Addendum No. 8

Reference: Beverley Taylor Sorenson Center for the Arts
Southern Utah University – Cedar City, Utah
DFCM Project No. 12218730

Subject: **Addendum No. 8**

| project | Southern Utah University Beverley Taylor Sorenson Center for the Arts Utah Shakespeare Festival Facility |

Large Scale Plumbing Plans
U-P401

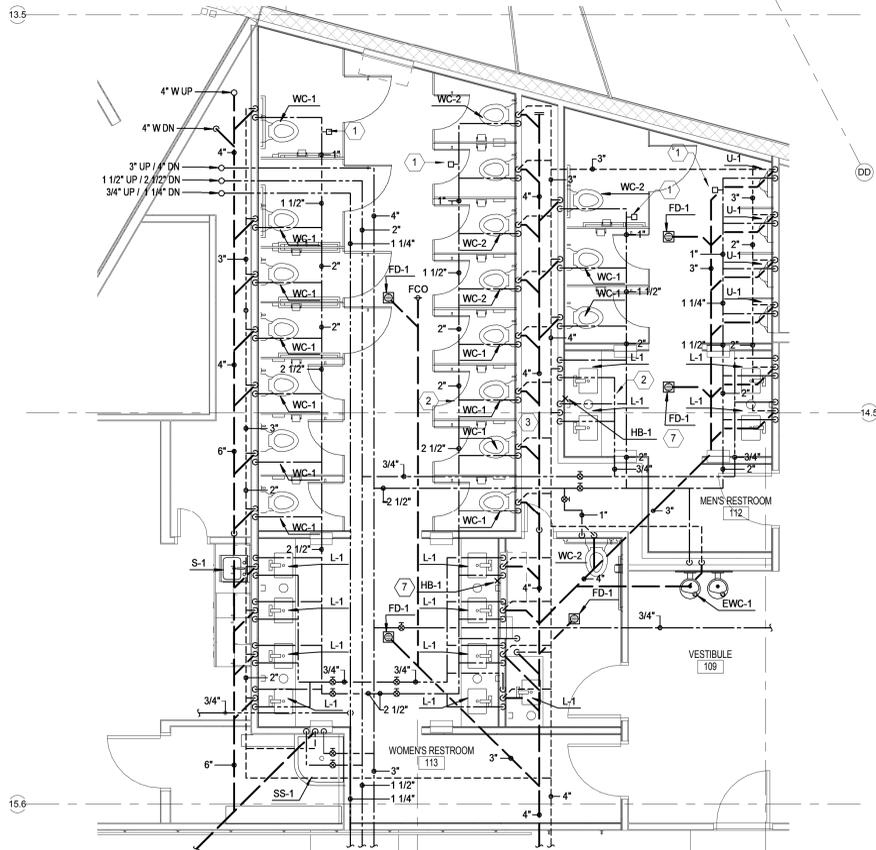
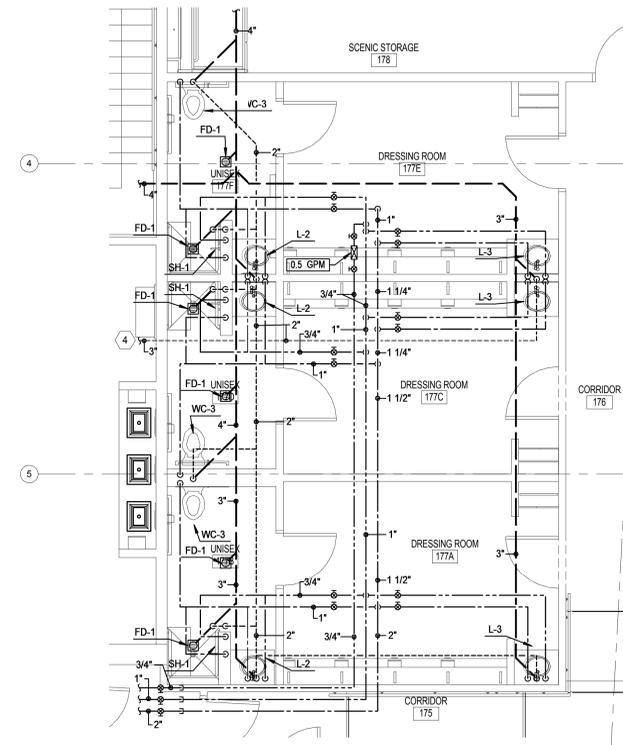
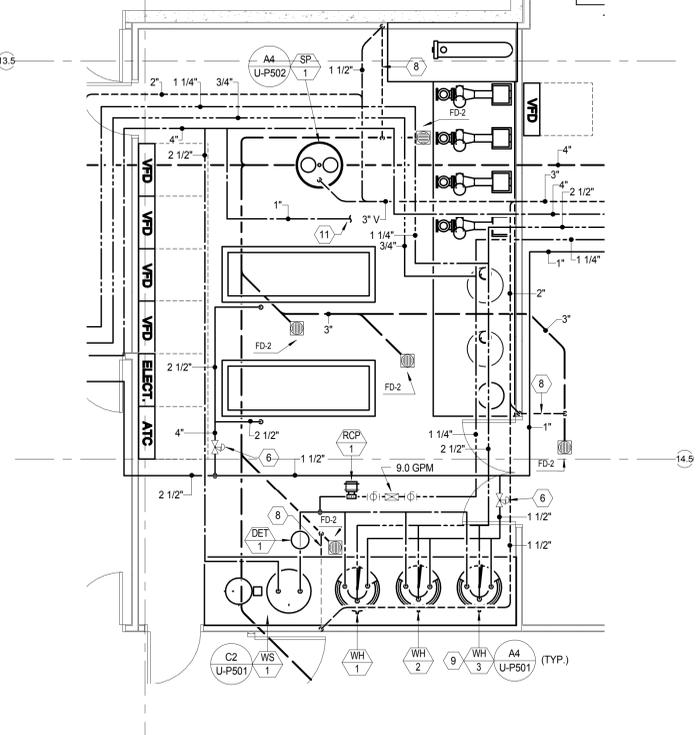
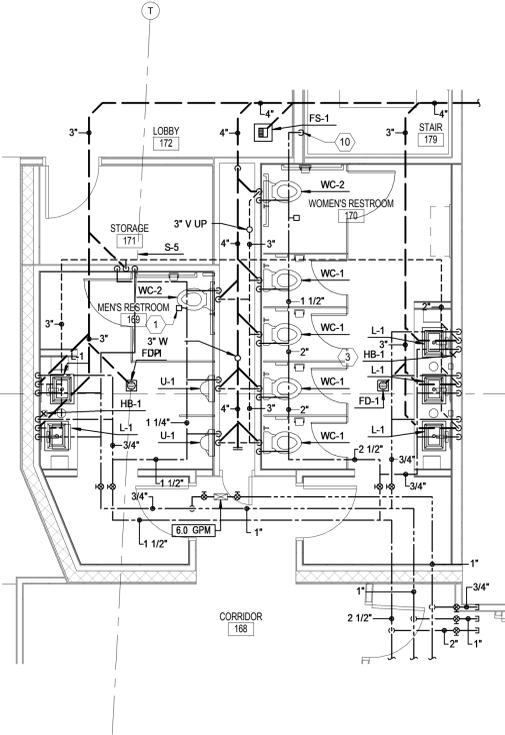
| | Clarification | U-P401 | <ul style="list-style-type: none"> The following item was changed in Addendum #06 but was not updated on the conformed set: "Refer to A2/U-P401. Provide and install sink S-1 as shown in attached supplementary drawing." See revised drawing. |

Electrical Site Plan
U-ES001

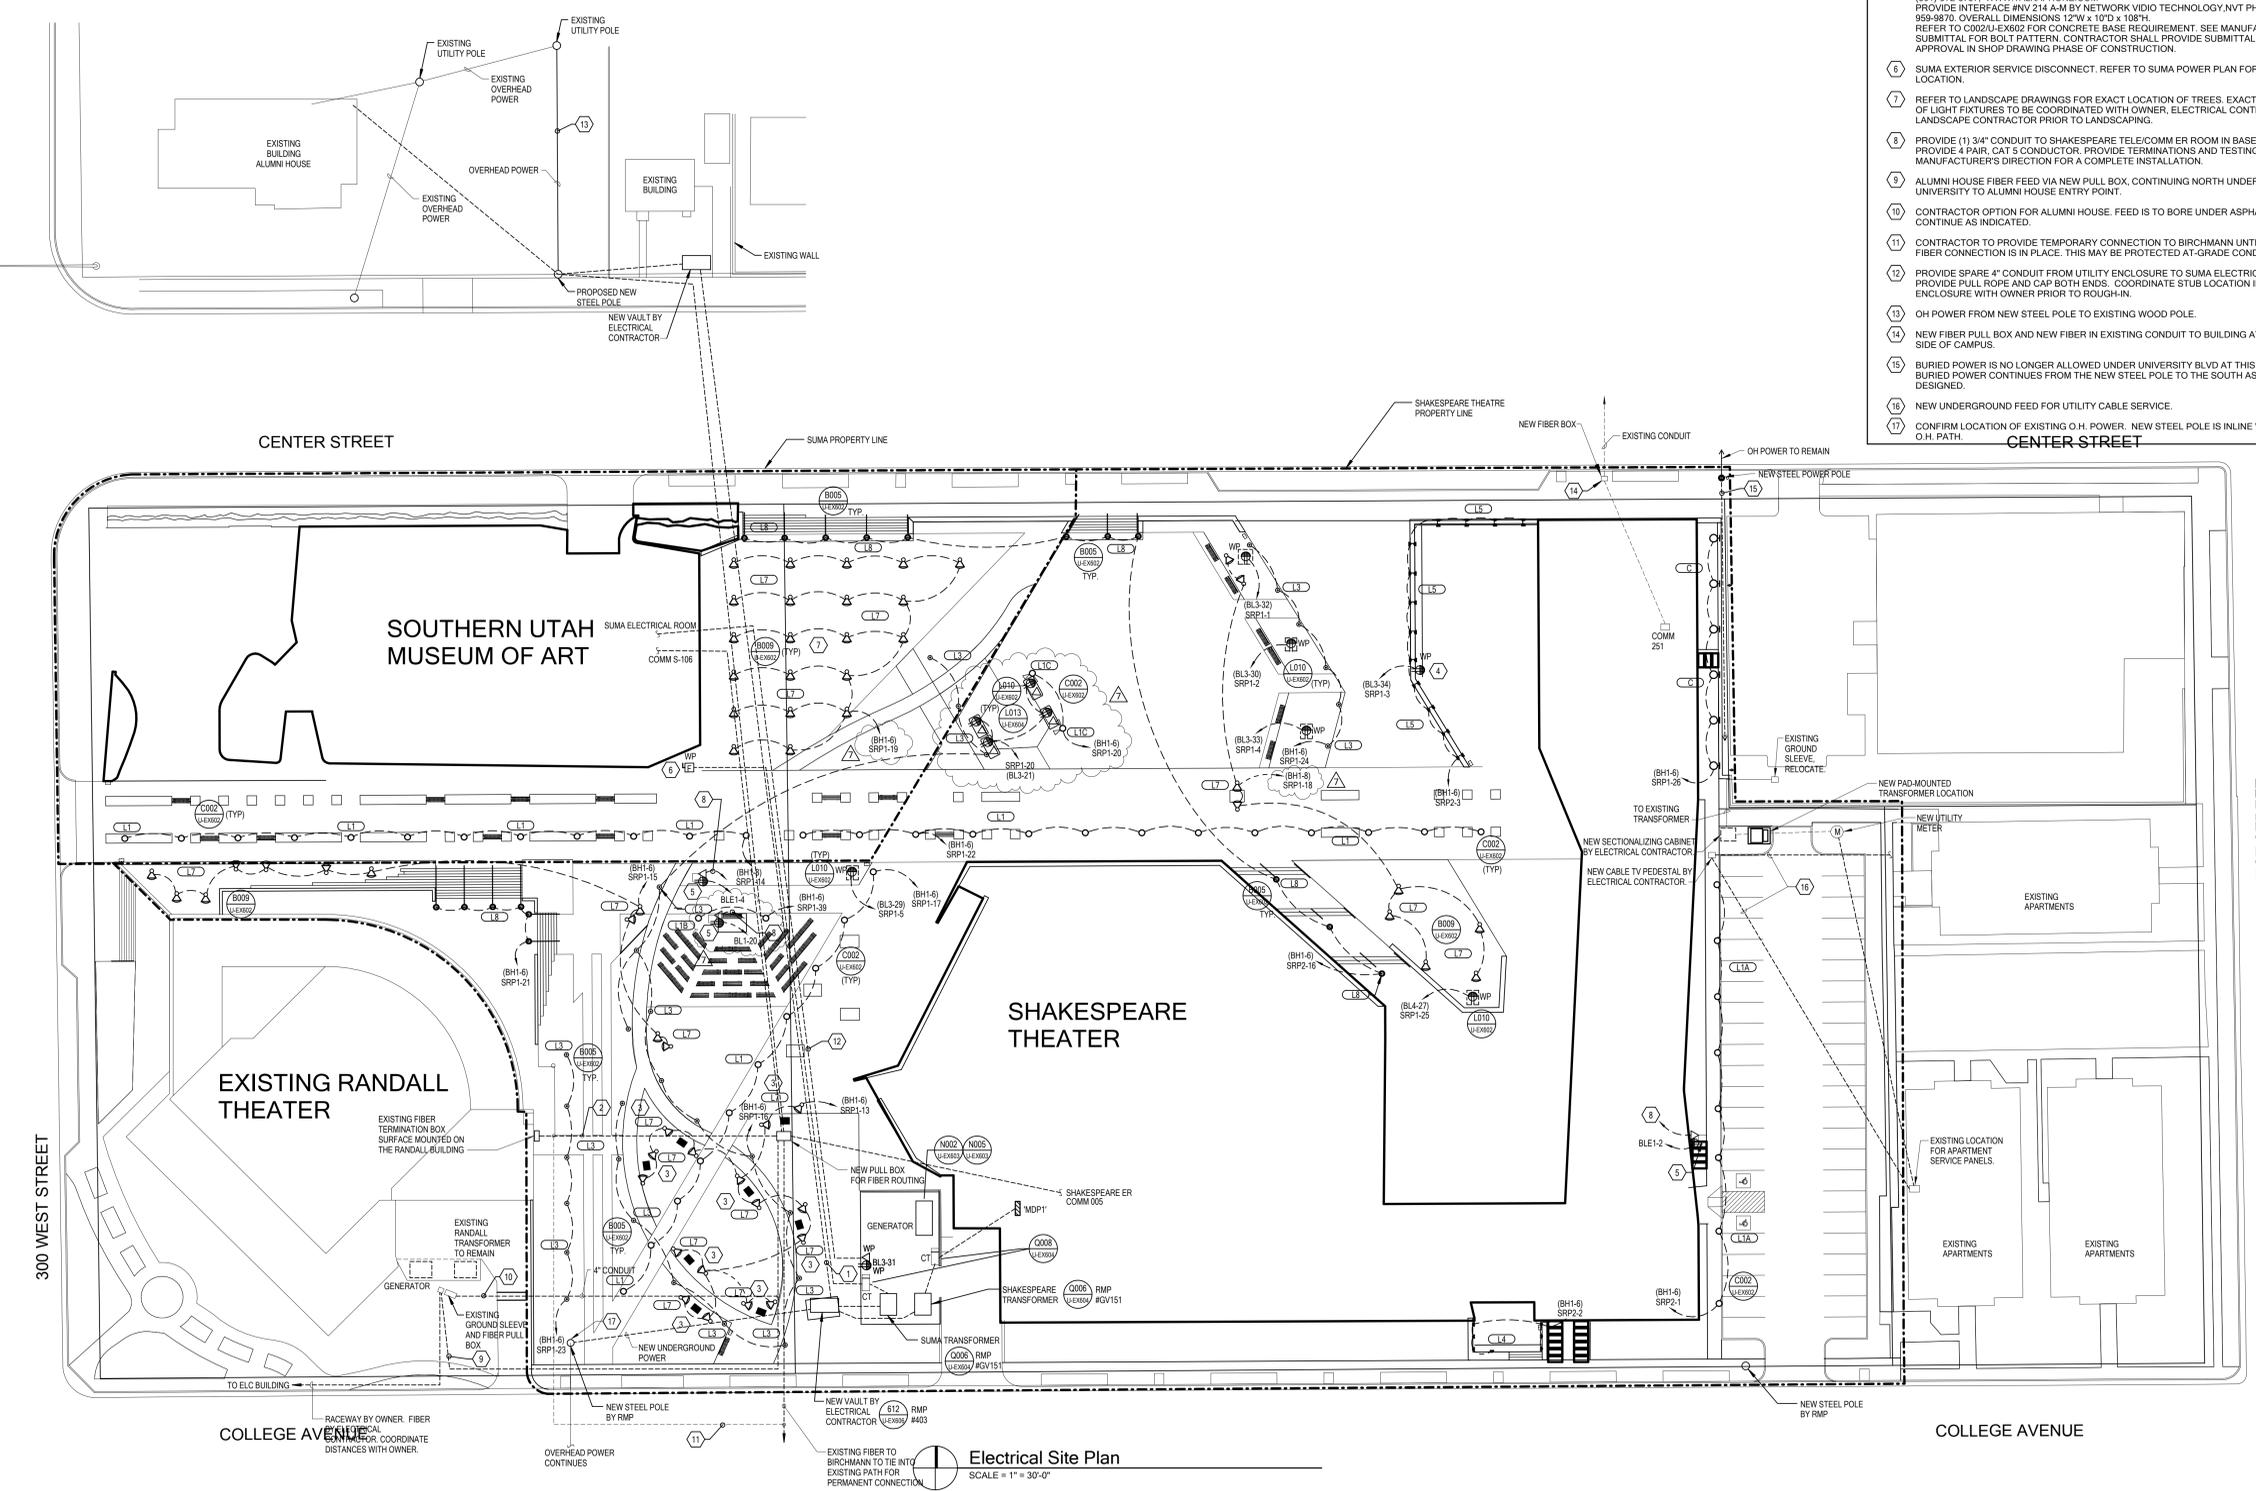
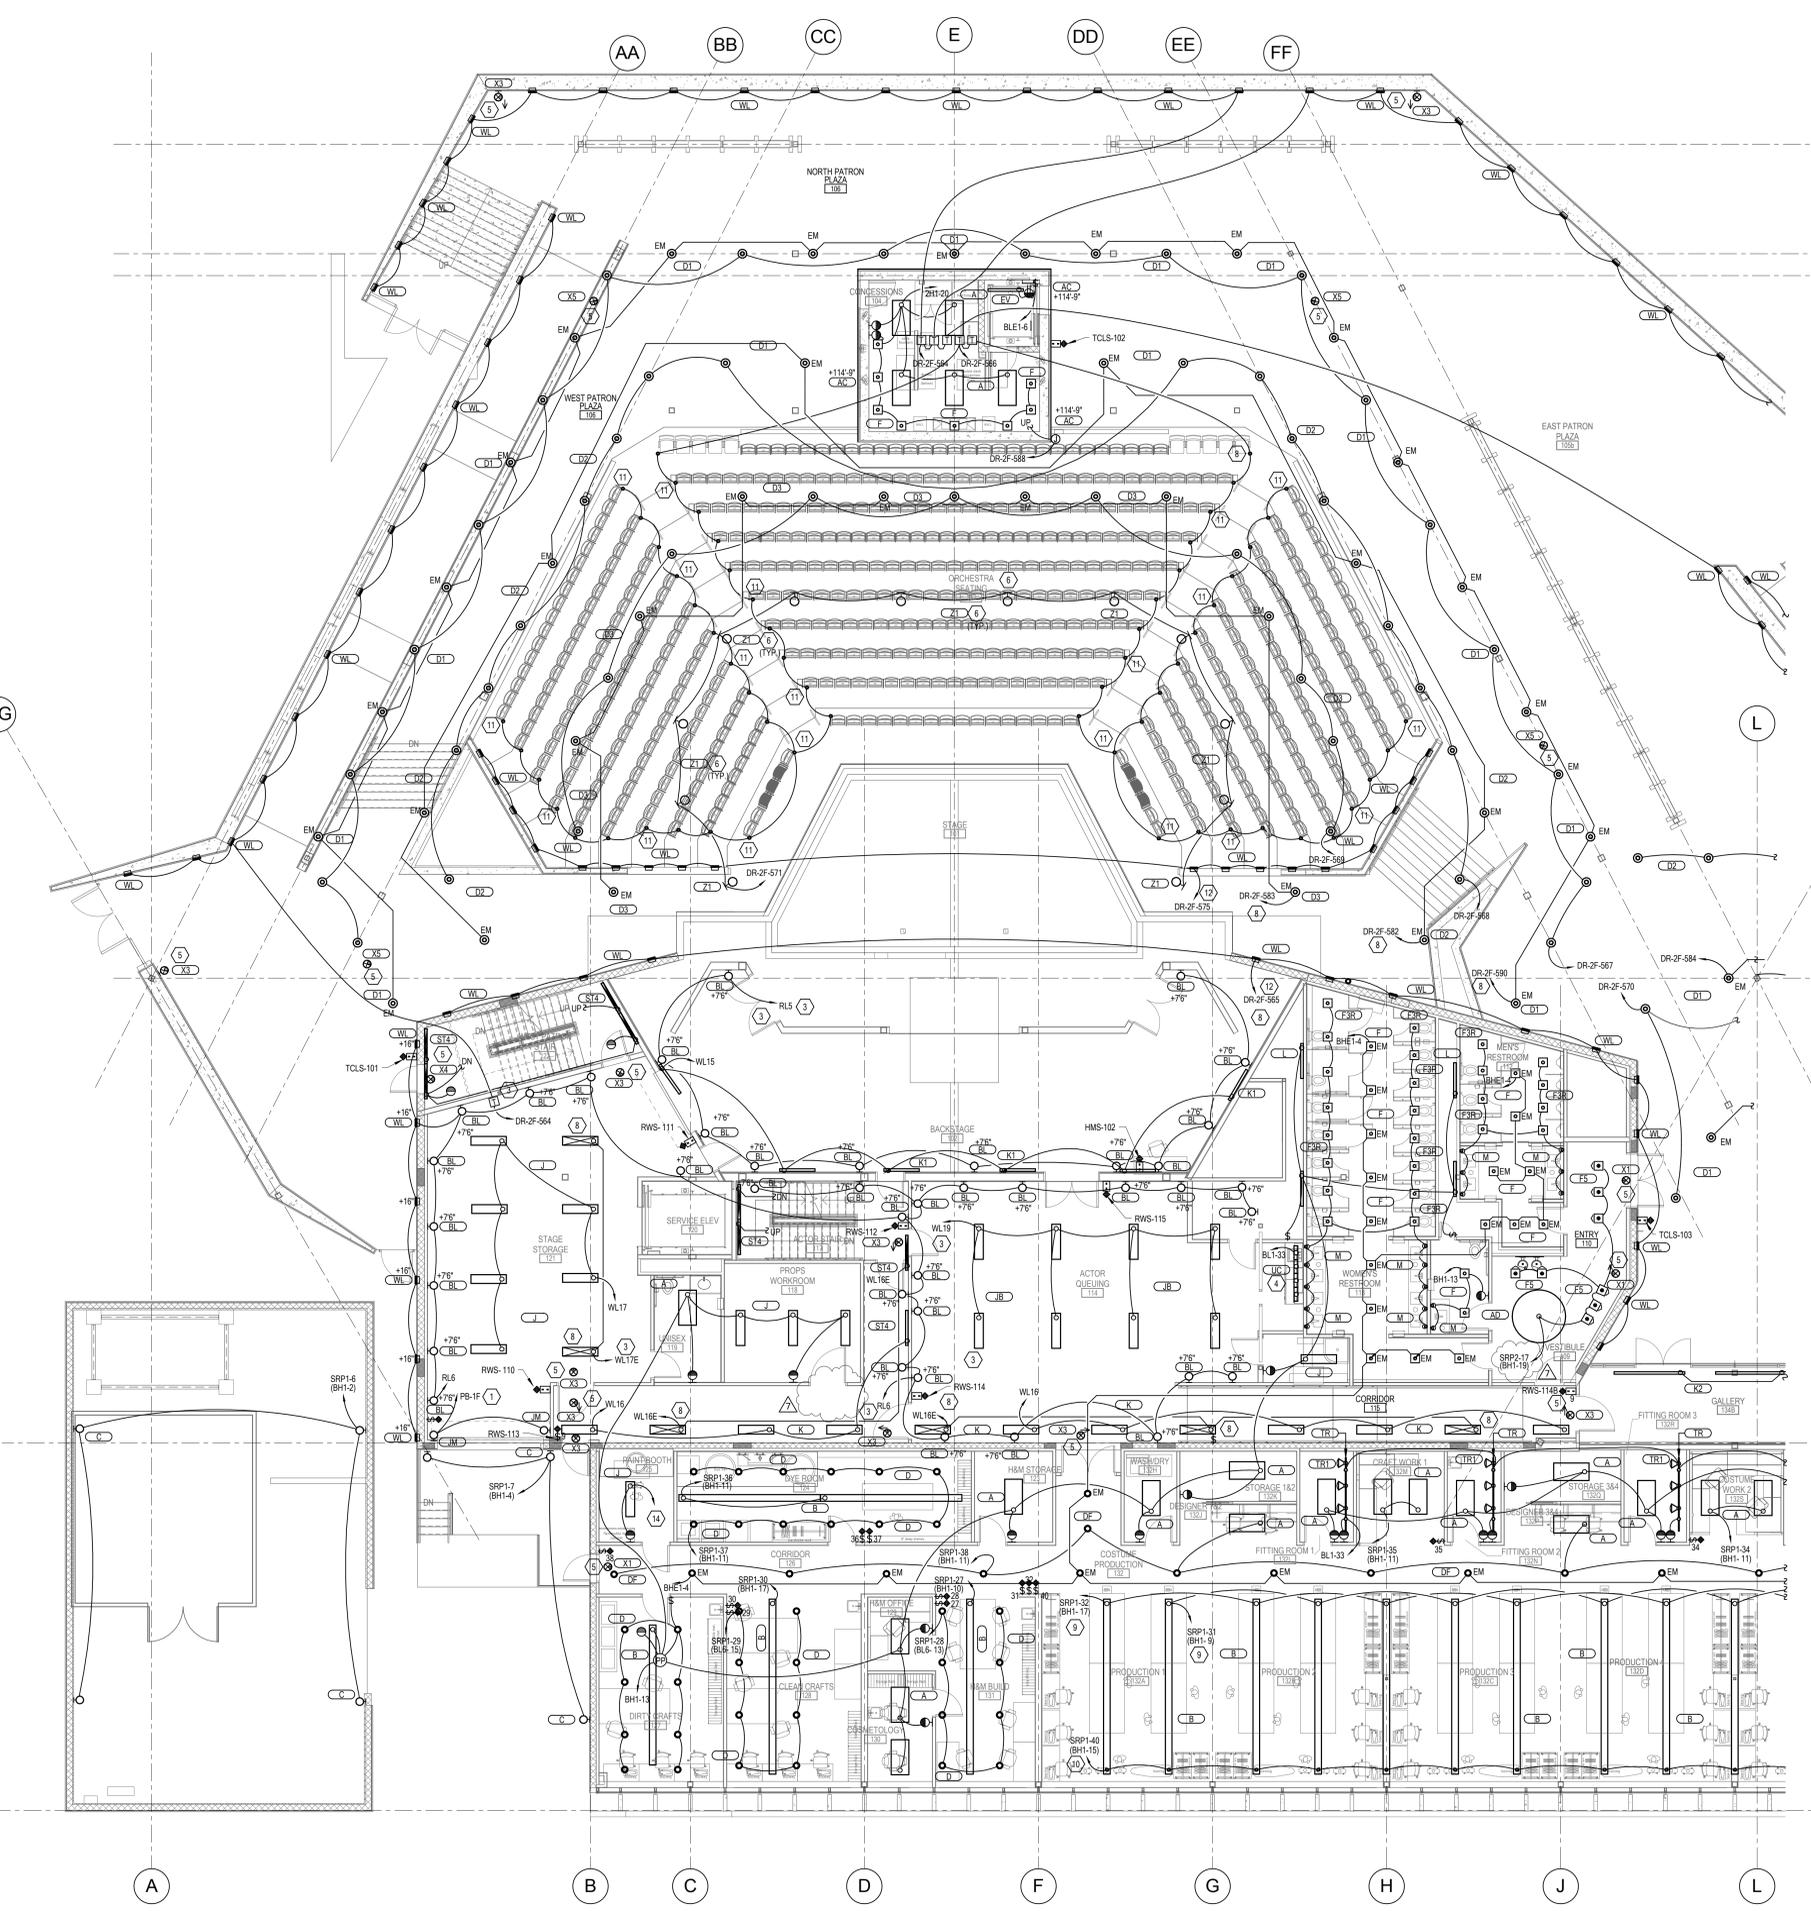
| ELECTRICAL | | | |
|------------|---------------|------------|---|
| | Clarification | U-ES001 | <ul style="list-style-type: none"> Change relay for Tree lighting L7 light fixtures from SRP1-18 to 19, east of the Green Show Stage. Green Stage. See site plan for addition of (4) ingrade weatherproof boxes with power and data. See added diagram on sheet U-EX604. Seminar Grove. Provide power/data pedestal. Provide gfci protected outlet. Provide shielded CAT 6 and surge suppressor for data outlet. Coordinate exact location with architect prior to rough-in. See diagram R017/U-EX602. See sheet for circuiting. Incorporate a key switch into pedestal for control of wireless microphone. Coordinate with a/v installer. |
